Recall Bulletin

Transport Canada Recall Number: **04-420**

SAFETY DEFECT - Bus Emergency Exits Installation of Slam Stops.

1996-2004 ORION V BUS MODELS- THE SERIAL NUMBERS OF THE AFFECTED VEHICLES ARE ATTACHED.

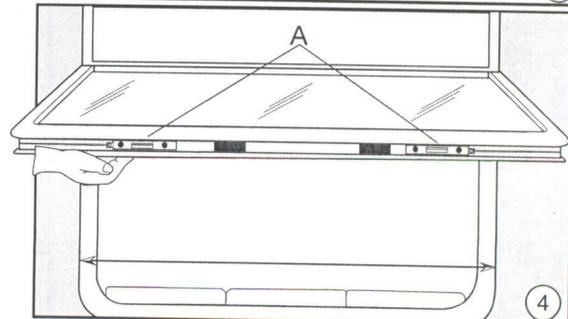
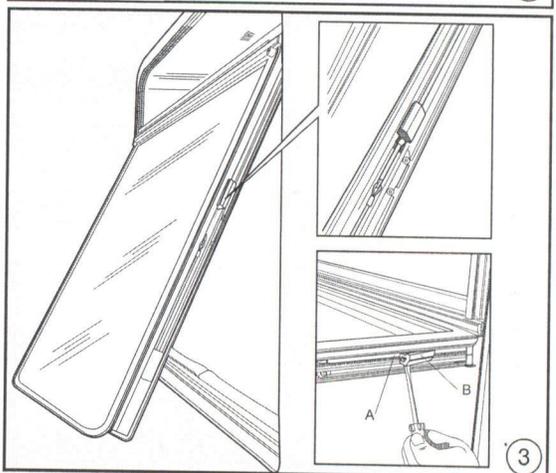
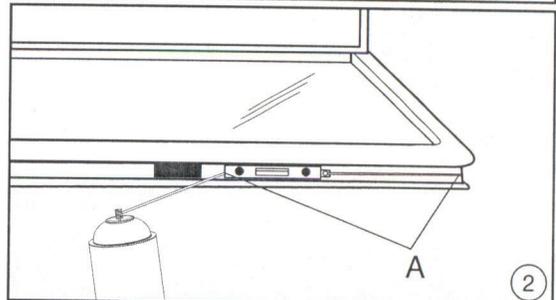
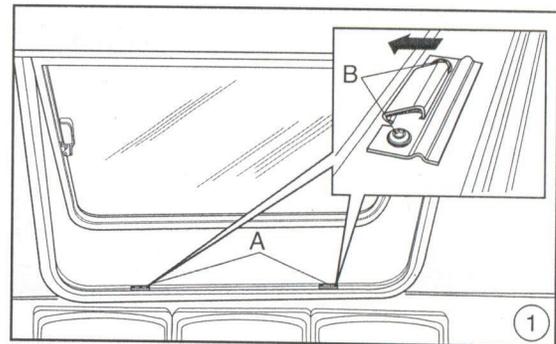
1. On egress windows that over-shut, open window and clean area (FIG 1), apply penetrating oil on outer frame, such as CRC-36 or LPS-1. Check to see that release bolts are working freely, clean and lubricate if necessary with a high quality spray lithium grease (FIG 2).
2. Prop window open to approximately 45 degrees so that the underside of the egress frame is accessible from underneath (FIG 3).
3. Measure the window width from the outside of the bus (FIG 4). If window is less than 58" wide (measure across outside of outer frame), go next page - SMALLER WINDOWS - 58" OR LESS.

4. Using the fixture provided, place the tool in the lower portion of the frame, with the fixture locating bar resting on the division bar and nestled in the window track that is closest to the inside of the coach (FIG 5). You should be looking up at the bottom of the window. The fixture is designed to drill two holes at each side of the division bar.

5. Before drilling use a little cutting oil (WD-40) on the drill to prevent chip loading on the drill. Drill two holes, 11/64" diameter, to the front side (towards the front of bus) of the division bar (FIG 6) and flip the drill fixture to drill two additional holes in the rear side (towards the rear of the bus) of the frame (FIG 8).

6. On the inside of the coach, use a 1/4" drill to de-burr the holes prior to installing the screws.
7. From inside the coach, place the T543-50 slam stop in the egress frame channel and align the holes (FIG 7). Secure with two #272-015013 screws. Do not overdrive fasteners; use a 30 in/lb torque setting on the screw gun or set by hand.

8. Repeat for other side (FIG 8).

SMALLER WINDOWS - 58" OR LESS

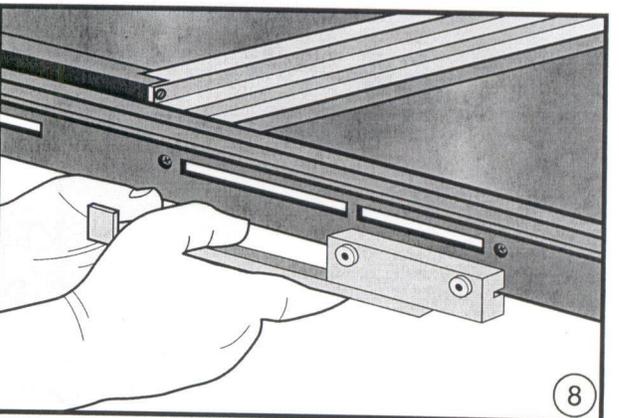
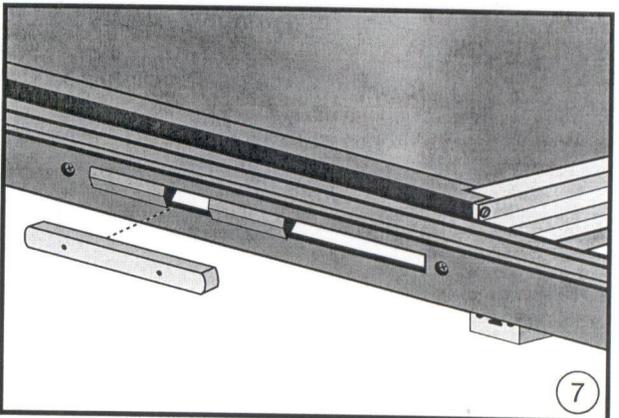
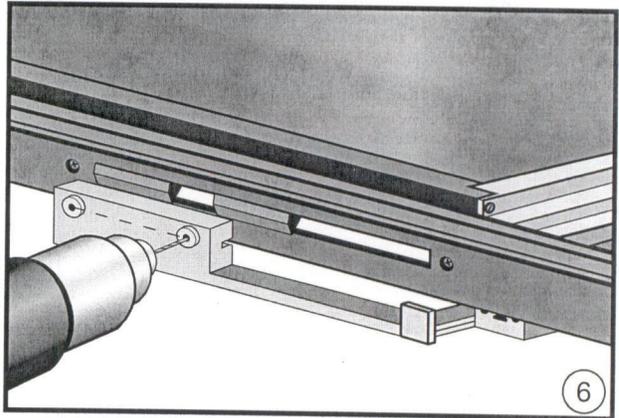
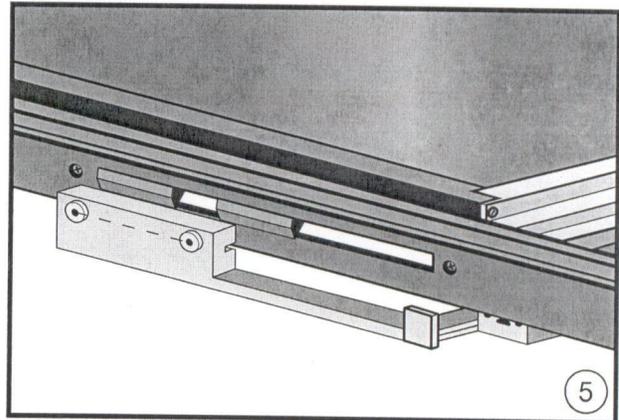
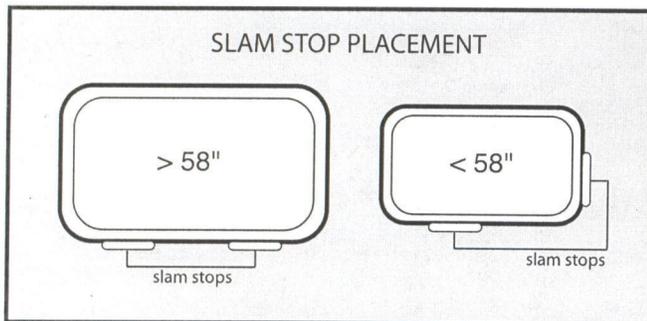
1. Drill two holes in the track on the bottom side of the window as in the wider ones, in the area facing the front of the bus (BELOW). DO NOT DRILL THE HOLES IN THE OPPOSITE SIDE.
2. Move the drill fixture to a point that is at the rear of the window frame; locate just above the tangent point on the frame so that the drill fixture is in a vertical position. Make sure that the drill fixture is on the inside portion of the egress window.
3. Before drilling use a little cutting oil (WD-40) on the drill to prevent chip loading on the drill. Drill two holes and secure with screws as indicated above in steps 6 & 7. Test for FMVSS compliance.
